Construction of pressure vessel---General principles

ERRATA

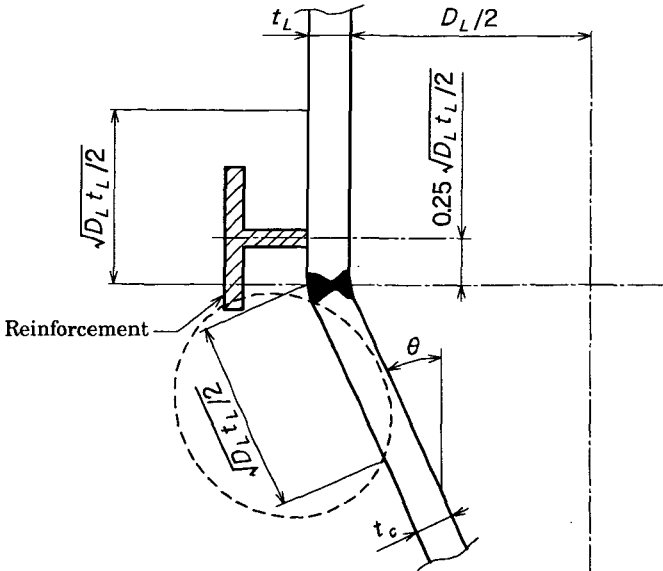
Page	Position	Error	Correct
117	Annex 1 Figure 3	Replace the figure with following:  ( : corrected position)	
119	Annex 1 Figure 6	Replace the figure with the following:  ( : corrected position)	
188	Annex 3 clause 2, B_1	$B_1 : B + g_0$ (mm) (in the case of an integral flange $f \geq 1$)	$B_1 : B + g_0$ (mm) (in the case of an integral flange $f \geq 1$) $B + g_1$ (mm) (in the case where f given by Annex 3 figure 4 is smaller than 1, though the minimum value of f adopted for loose flange and integral flange is 1)
